ROBBEN ISLAND MUSEUM: OLD POWER STATION

REPORT No.4: REINSTATEMENT, RETENTION, REMOVAL, REPLACEMENT AND MODIFICATION OF HISTORIC FABRIC

Fig.1. Ca 1963 tracing showing roof ventilator

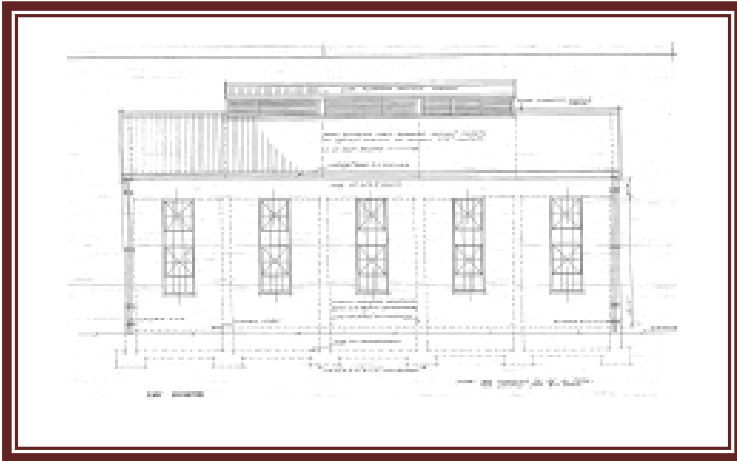
The original design proposal provided for the reinstatement of the roof ventilator shown in the ca 1963 tracing from an earlier architectural drawing. The reasoning for the reintroduction was that it would allow for the ducting of the new air conditioning plant, wiring, pipes and other services required for the storing of artefacts.

The reintroduction contradicts RIM's 1996 policy, has no value from an engineering perspective and will not provide any volume saving.

The two current roof ventilators are asbestos fibre cement. One is situated on the SE pitch of the roof approximately on grid line 'B', the second is situated on the NW pitch approximately between grid lines 'D' and 'E'. Both will need to be removed, sealed and placed back in situ. They may only be replaced if matching fibre cement ventilators are available and must be taken into the collection.

Corrugated asbestos roof sheets to be replaced with matching profile fibre cement to reduce asbestos register on Island.

Fig.4 to 6.
North
elevation

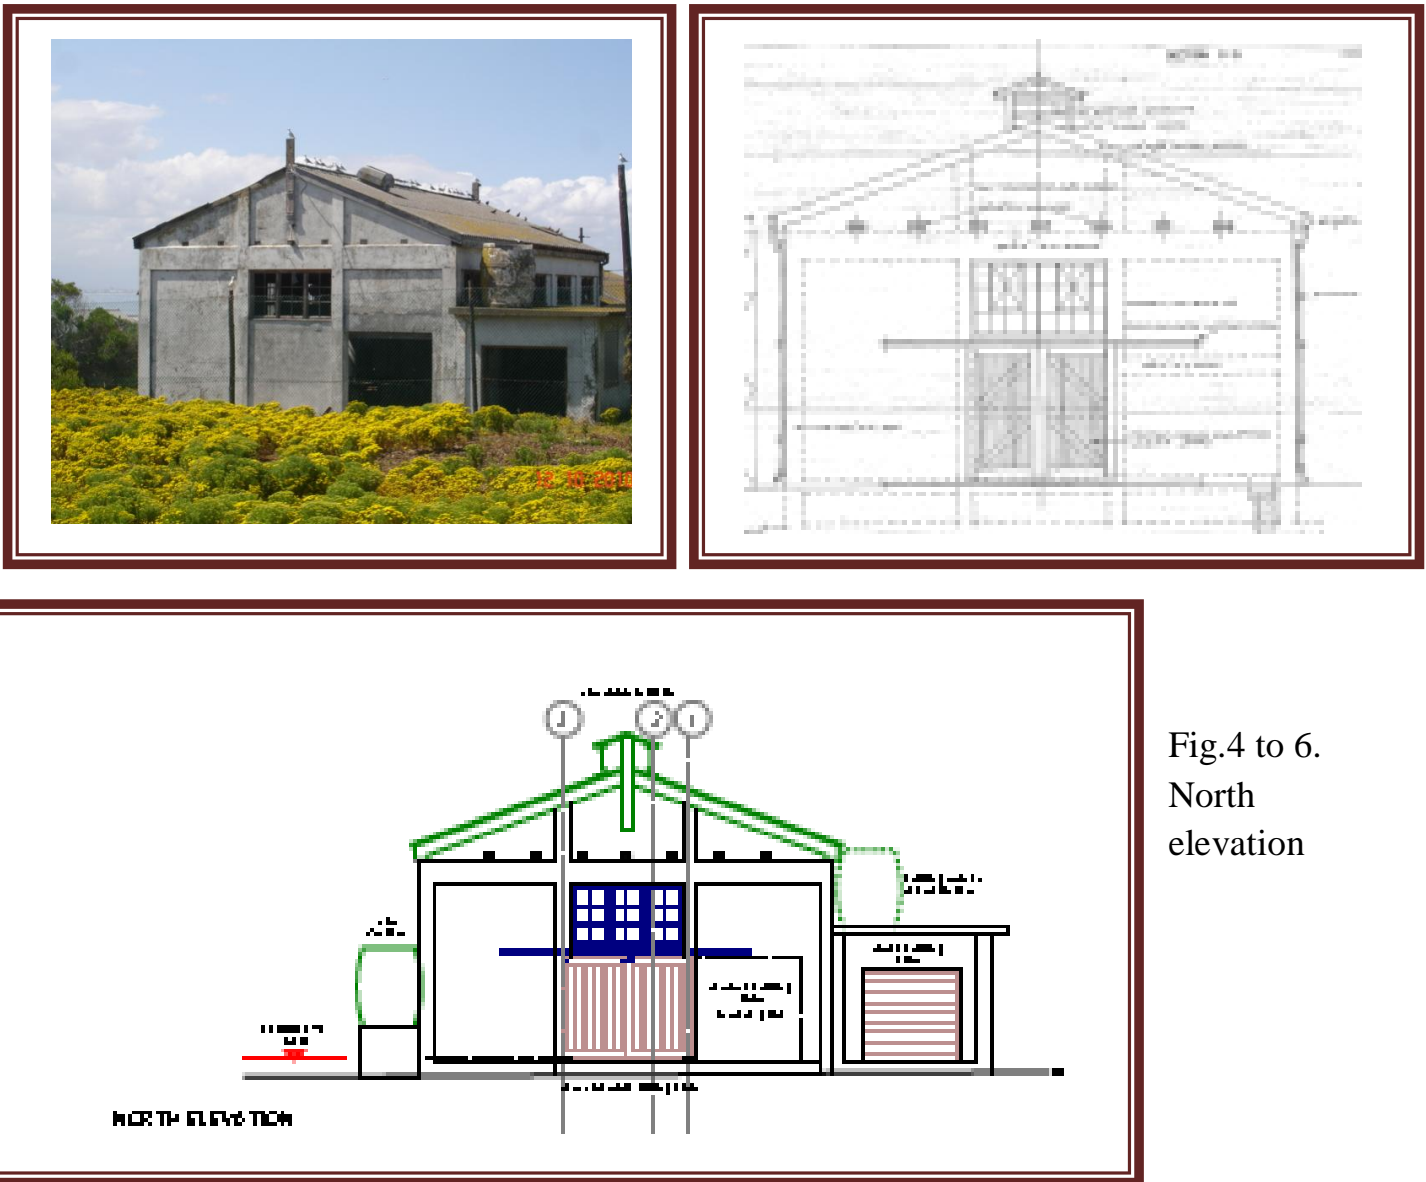
The door on the north façade shown in the 1963 architects drawing is to be reopened beneath the central window and the door replicated. This will mean the return of the symmetry of the original design and will allow for better access down a central axis throughout the proposed storage area. The present door ca 1980's would be bricked up. The outline to be scored in the plaster as an interpretation of this part of the history of the place. The door to the ca 1967 to 1970 transformer room to be retained and either repaired or replicated.

Fig.8.
Design
proposal
East
Elevation

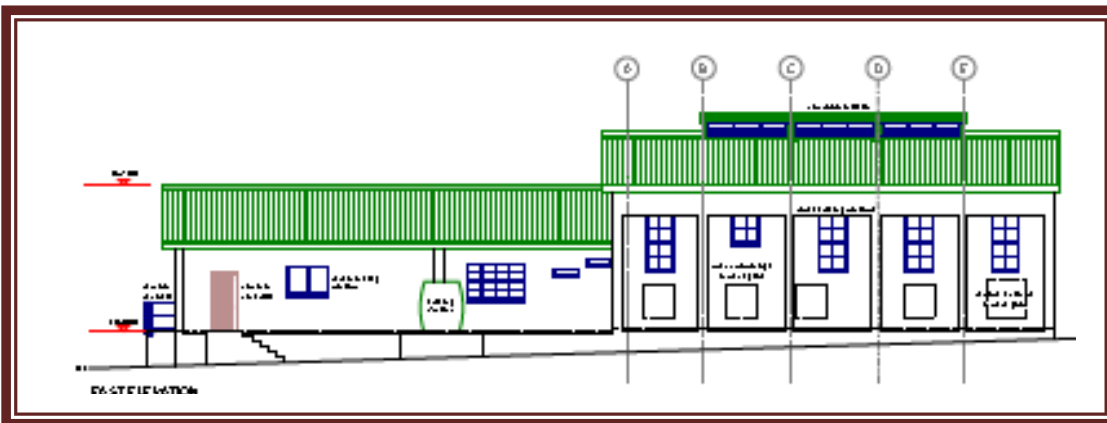
The window between gridline ‘B’ and ‘C’ on the east façade reflects two historical periods and is to remain as is. The lower bricked up part corresponding to the larger window is to be demarcated by differential plaster finish and outline scored in plaster.

Fig.27 to 29 Hoist and gantry

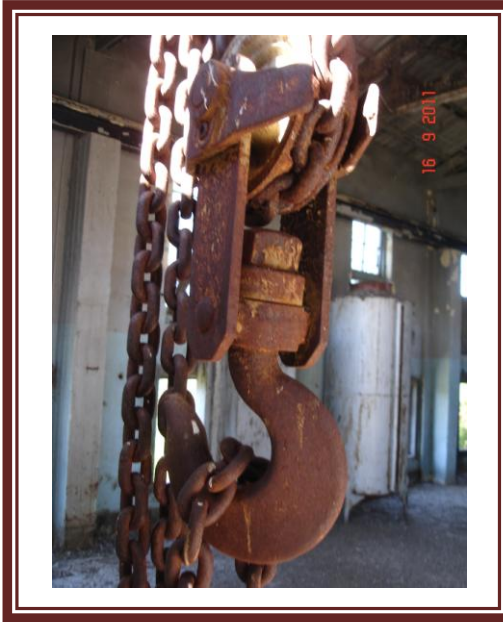
To be retained, de-rusted and decorated. Chain, pulley and hook component to be located in double volume space but moved along track to out of way adjacent to north wall to west of reinstated entrance.

Fig.37. Modified prison door

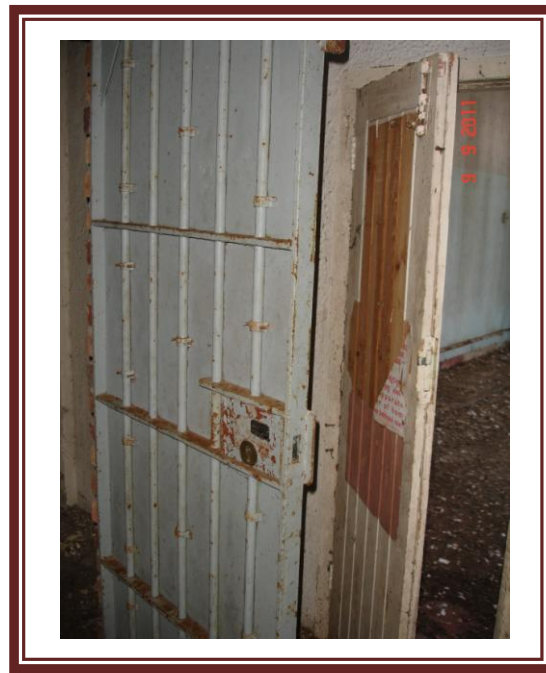
To be retained with lock function and operation to be restored. This store not to be independently fire proofed.
